PROJECT **123A90 - HOLLANDSE KUST NOORD WIND PARK**
BLPH Project

MECHANICAL COMPLETION DOSSIER (ONSHORE)

Junction Box 950-JE-04203 and Multi-core cable (FGS System)

1 -ELEMENT IDENTIFICATION

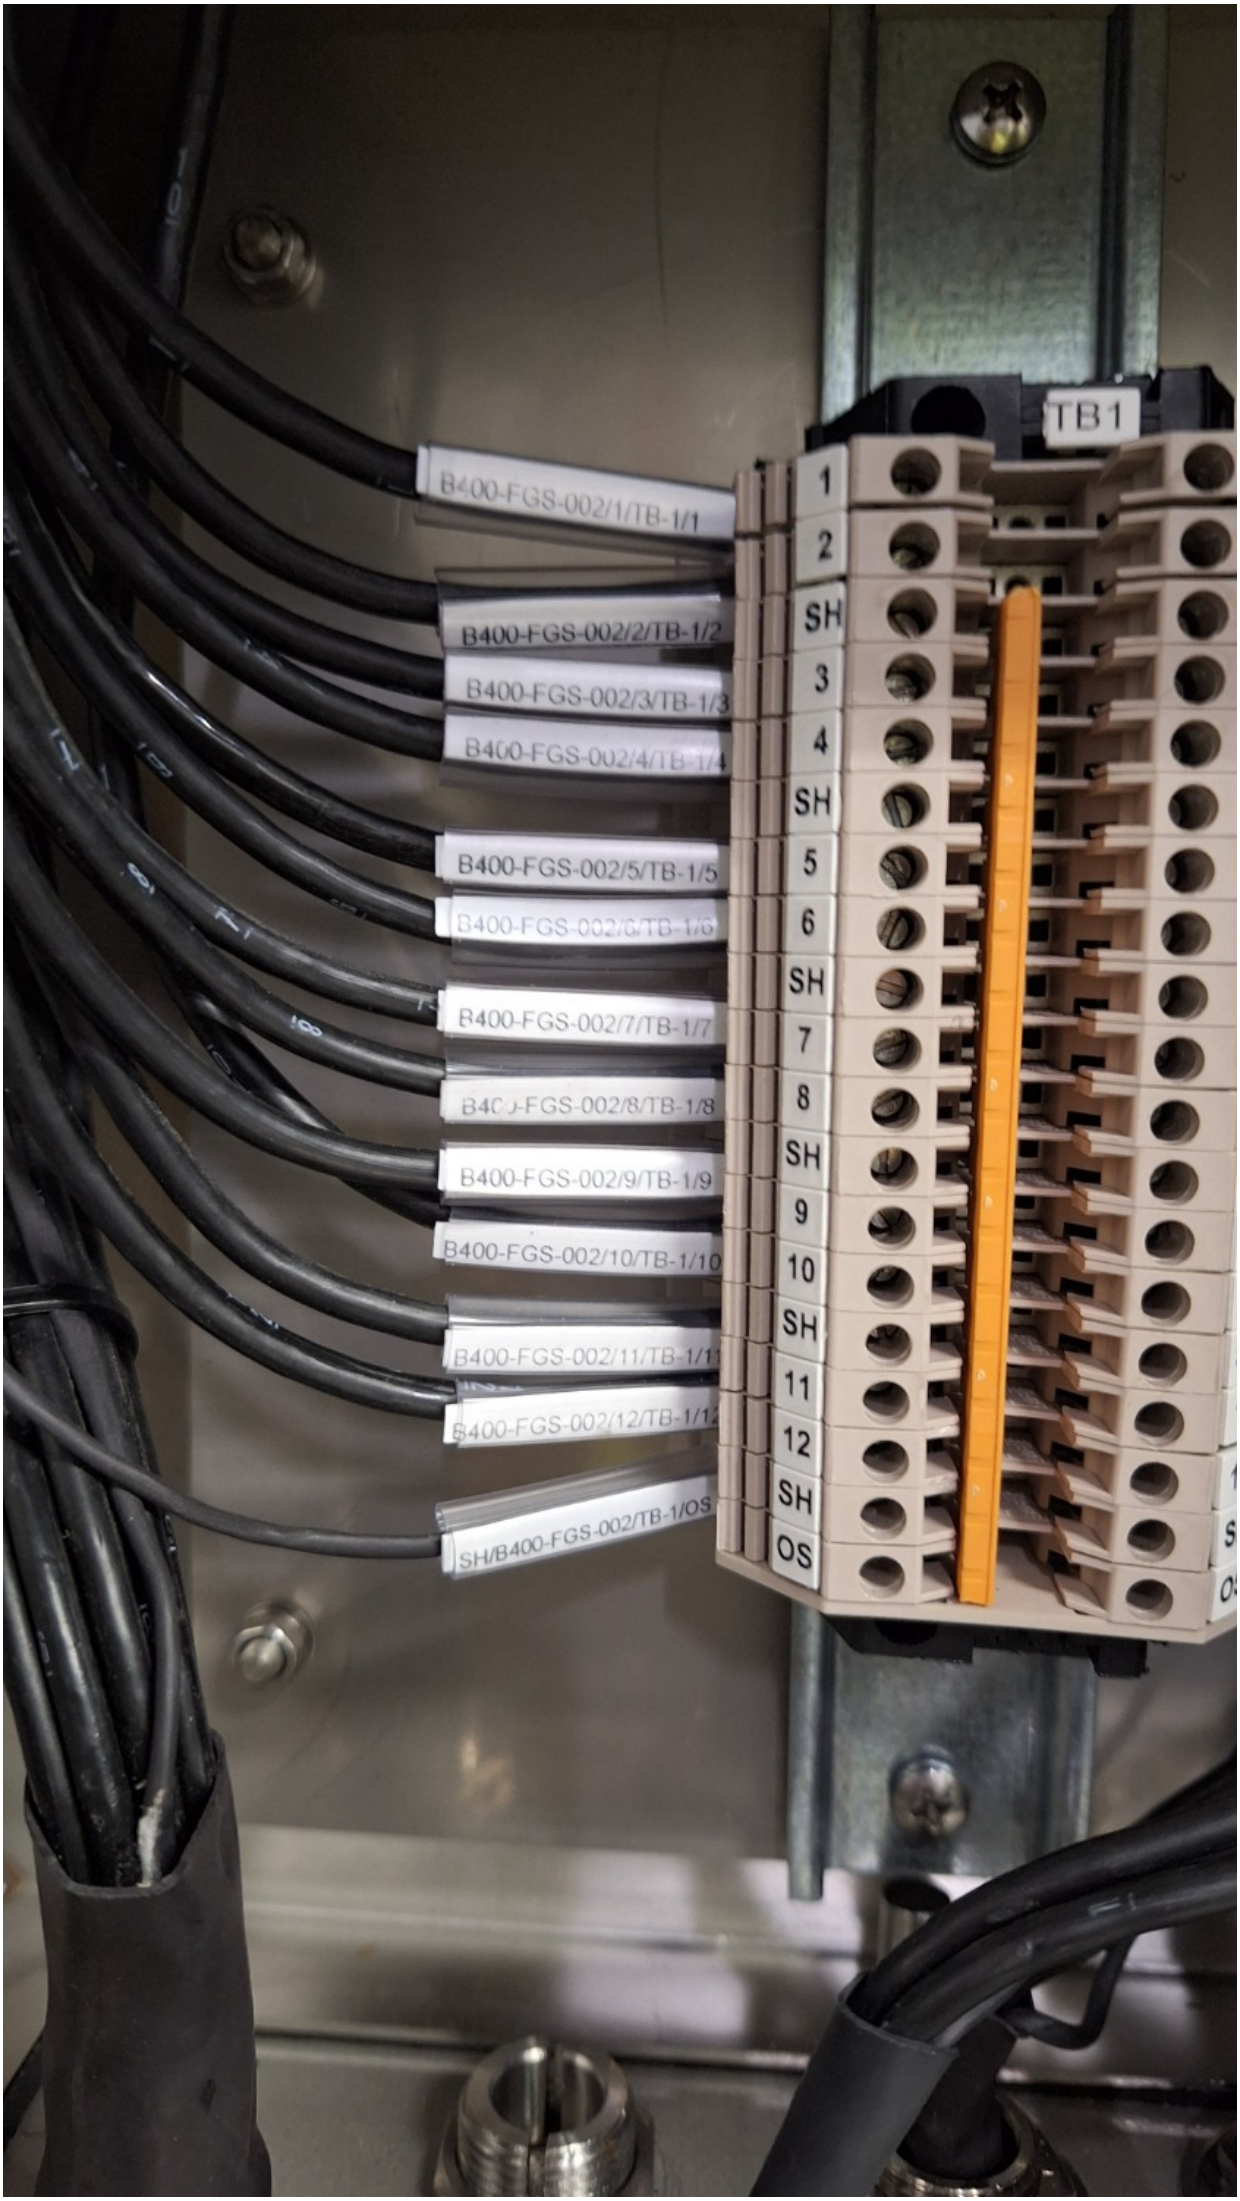
the philosophy of cross-ferruling are wrong J.B. side 950-JE-04203 . (see document 123A90-DDL-IN-DG-40016 sh.3)

DONE

PUNCH ITEM ENTRY / CLEARANCE FORM

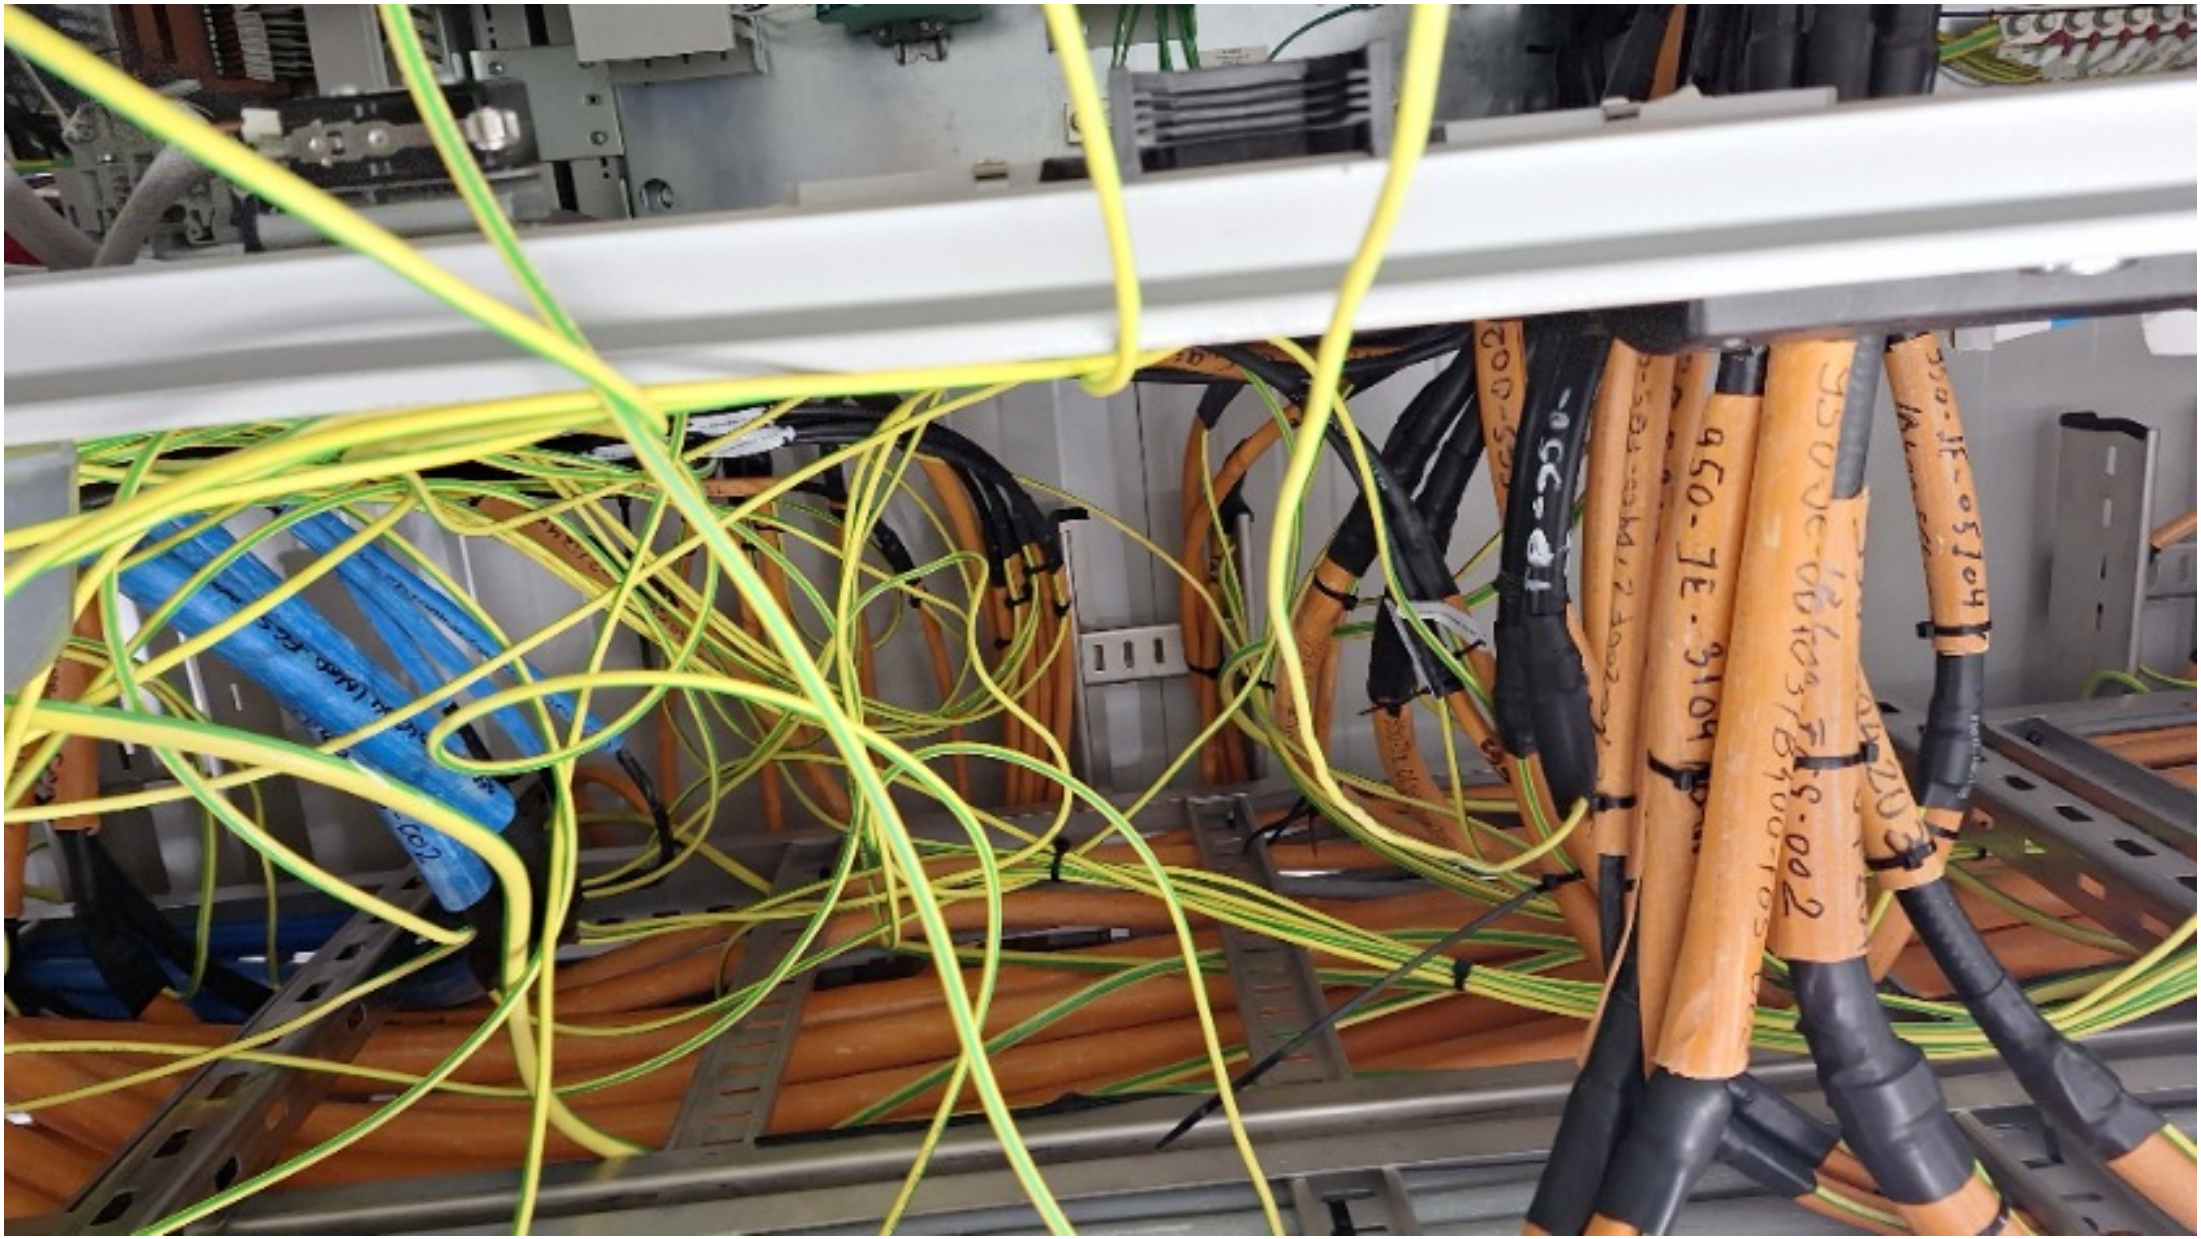
Missing the tag plastic project on the cable , cabinet input B400-FGS-002.

Installed.

PUNCH ITEM ENTRY / CLEARANCE FORM

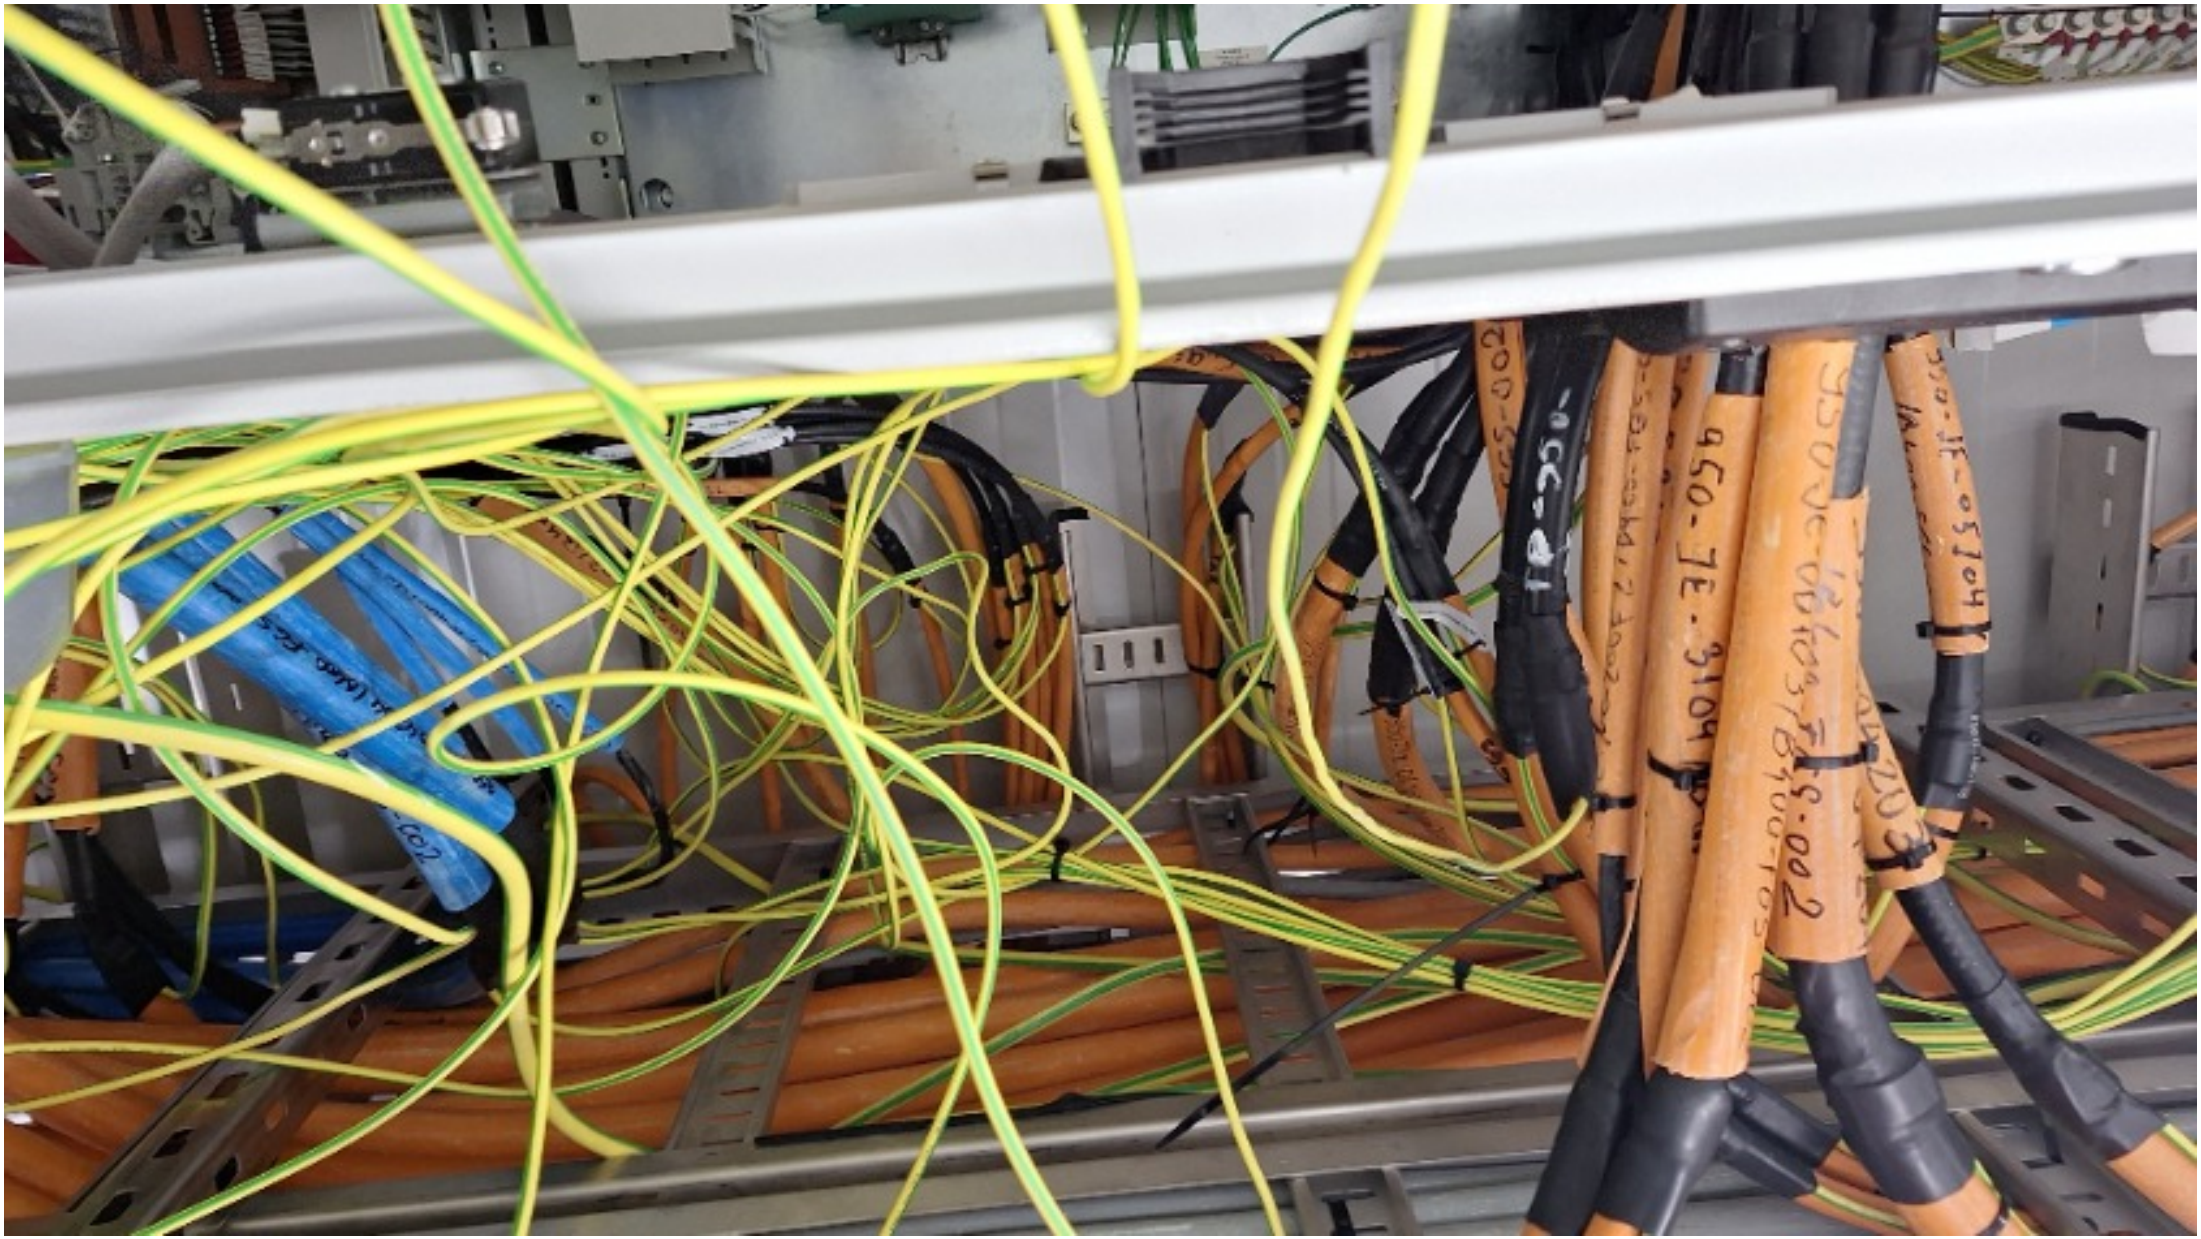
The cable armor is not connected to the reference BTM .

DONE

PHILOSOPHY OF CROSS-FERRULING: <01>

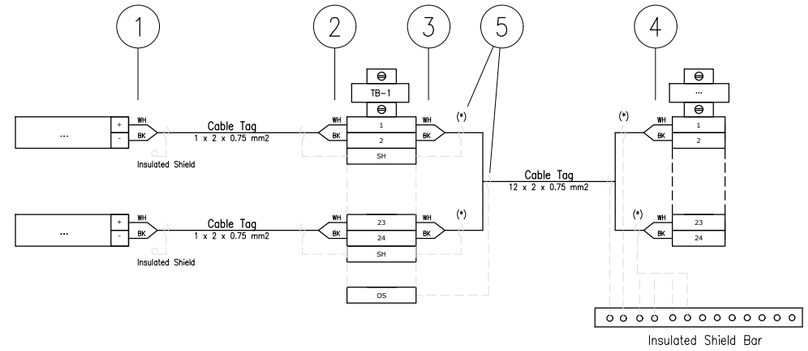
Missing the cross-ferruling (Cores) . Cabinet side B400-FGS-002 . (see document 123A90-DDL-IN-DG-40016 sh.3)
